Project	<b>IEEE 802.16 Broadband Wireless Access Working Group</b> < <a href="http://ieee802.org/16">http://ieee802.org/16</a> >
Title	<b>Amendment to RSA Security Primitives in 14.2.2.2</b>
Date Submitted	<b>2007-03-1508</b>
Source(s)	Jung-Mo Moon, Jeehyeon Na, Mi-Young Yun, and Sangho Lee <a href="mailto:jhna@etri.re.kr">jhna@etri.re.kr</a> ETRI 161 Gajeong-dong, Yuseong-gu Daejeon 305-700 Korea
Re:	Contribution on comments to IEEE 802.16g/D8
Abstract	Re-definition of RSA primitives in section 14.2.2.2
Purpose	Adoption
Notice	This document has been prepared to assist IEEE 802.16. It is offered as a basis for discussion and is not binding on the contributing individual(s) or organization(s). The material in this document is subject to change in form and content after further study. The contributor(s) reserve(s) the right to add, amend or withdraw material contained herein.
Release	The contributor grants a free, irrevocable license to the IEEE to incorporate text contained in this contribution, and any modifications thereof, in the creation of an IEEE Standards publication; to copyright in the IEEE's name any IEEE Standards publication even though it may include portions of this co

Figure 474 – RSA based Authentication Procedure

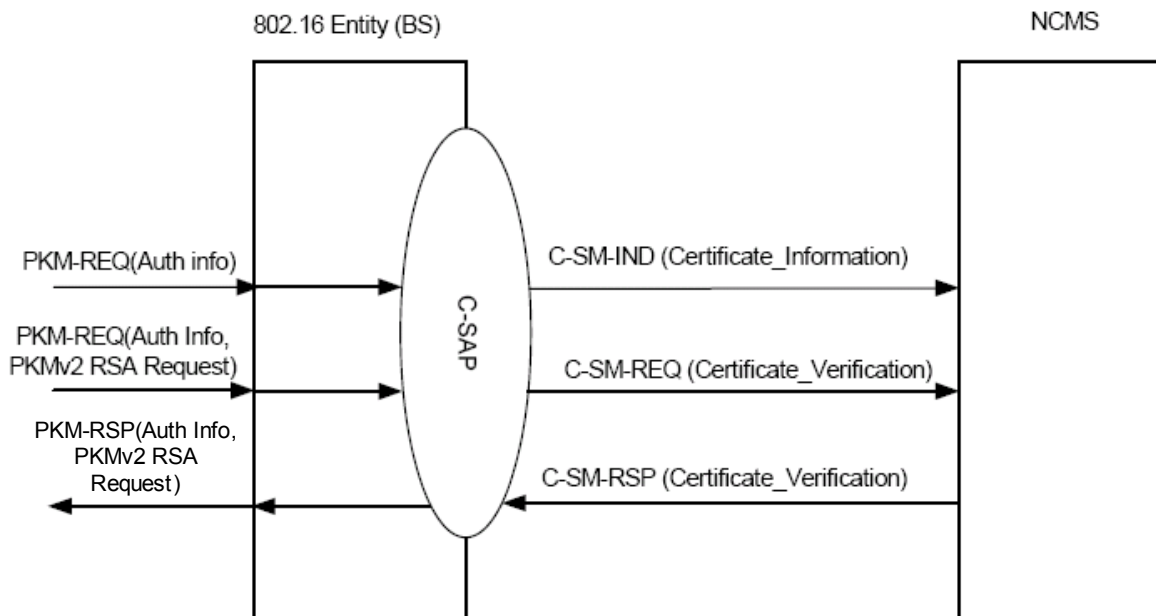
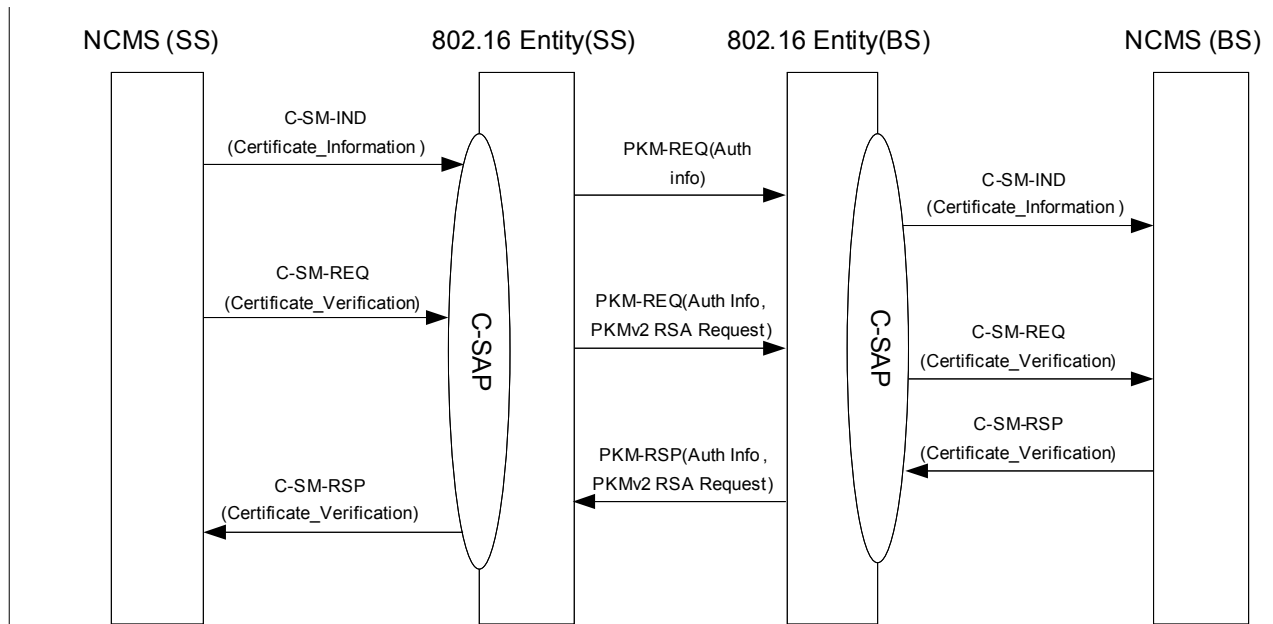
1. Modification of figure 474 which illustrate security primitives on the SS side.
2. Modification of each subsection to clarify and describes on each side (SS and BS side)

Figure 474 shows a RSA-based authentication procedure between an 802.16 entity a BS and ~~the~~ an NCMS on the MS side and the BS side entity as follows:
